SAN RAFAEL HIGH SCHOOL

MASTER FACILITIES LONG-RANGE PLAN AND STADIUM PROJECT

FINAL ENVIRONMENTAL IMPACT REPORT

Prepared for
San Rafael City Schools

Figure 4.12-3A

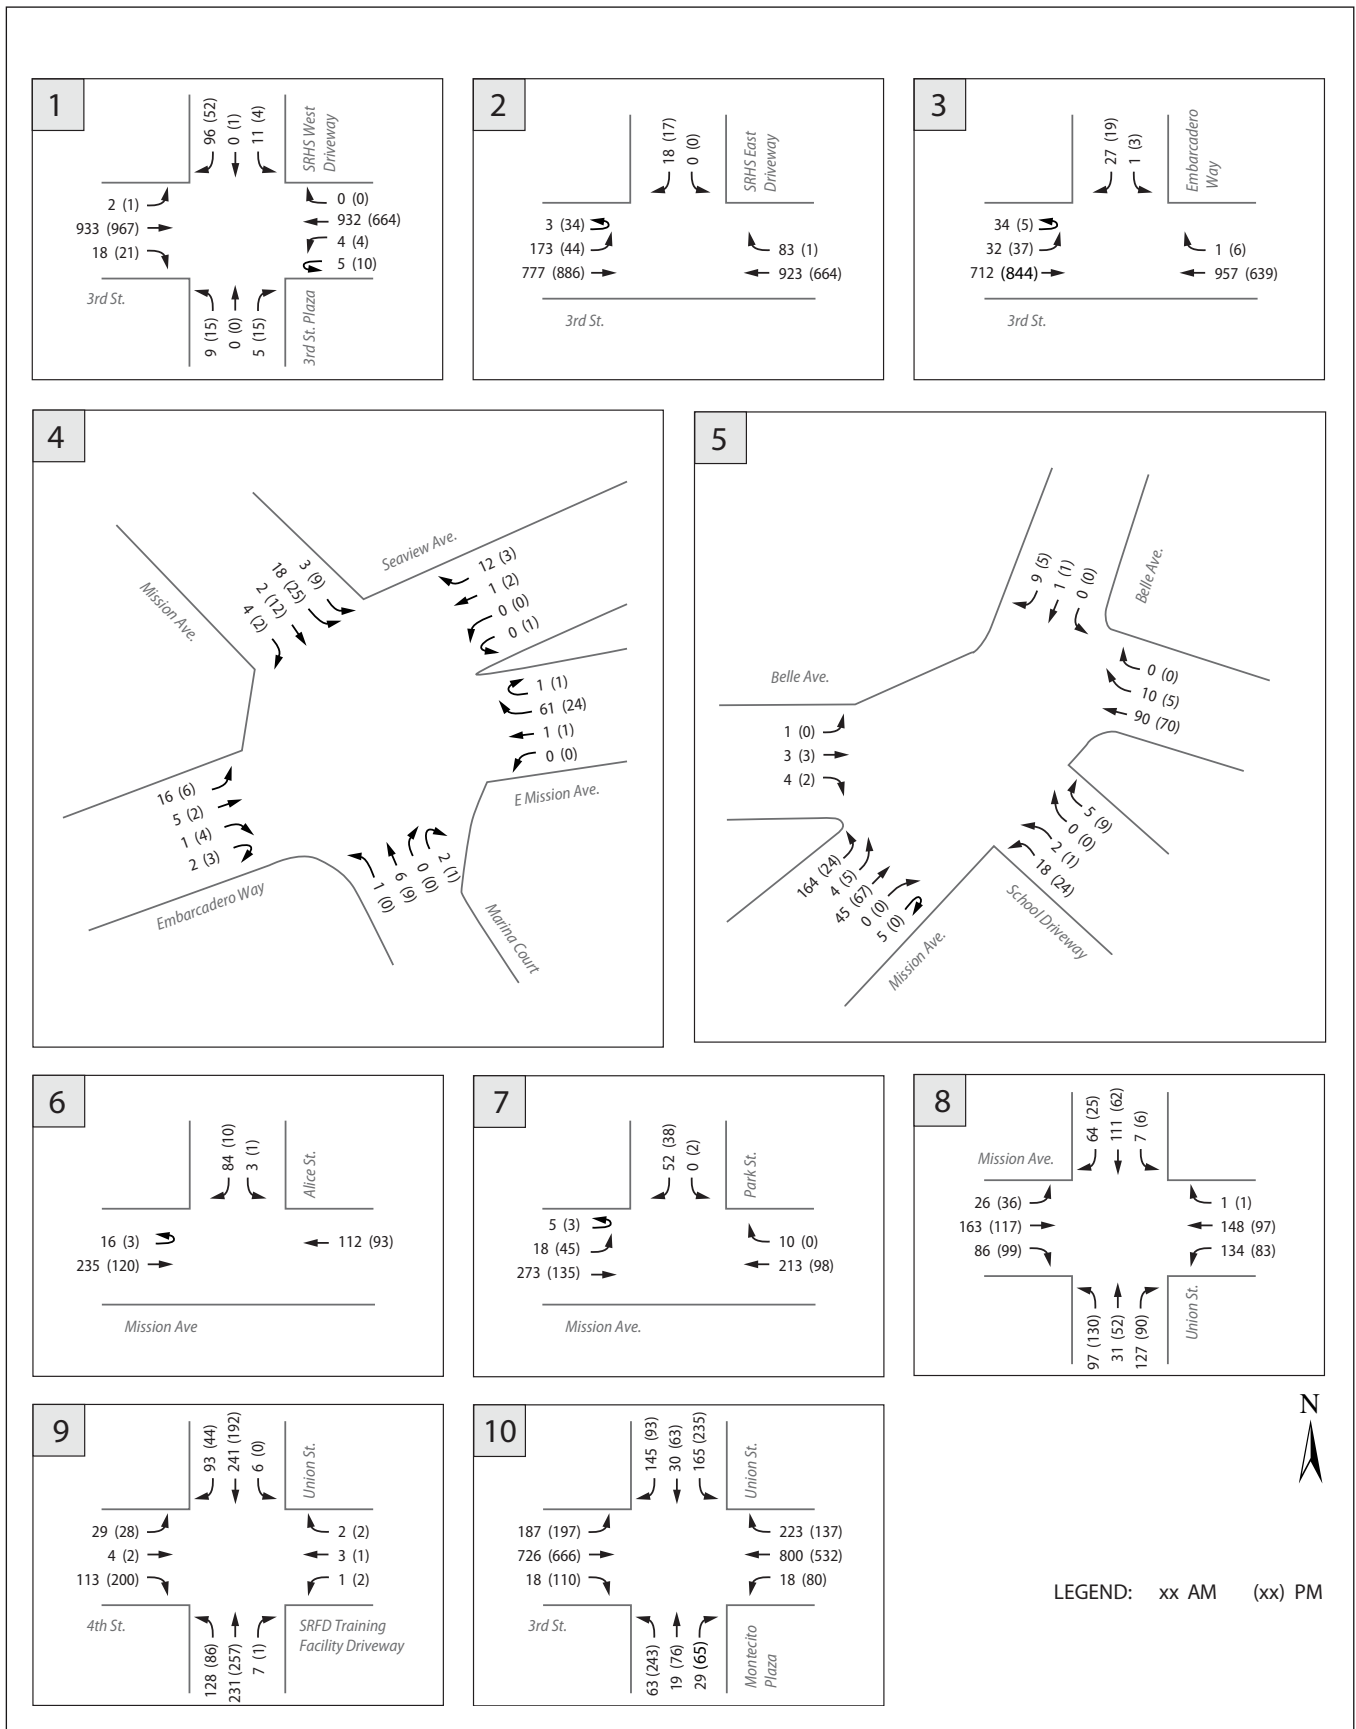
Page 4.12.25 (Figure 4-12-3A)

- A1-22 Comment noted. The referenced trip numbers in Figure 4-12-3A are typos. The figure has been revised to reflect 844 eastbound through trips during the evening peak hour at 3rd Street/Embarcadero Way and 65 northbound right-turn trips at the 3rd Street/Union Street intersection as shown in Chapter III..

Page 4.12-25, Figure 4.12-3A, is modified as shown on the following page.
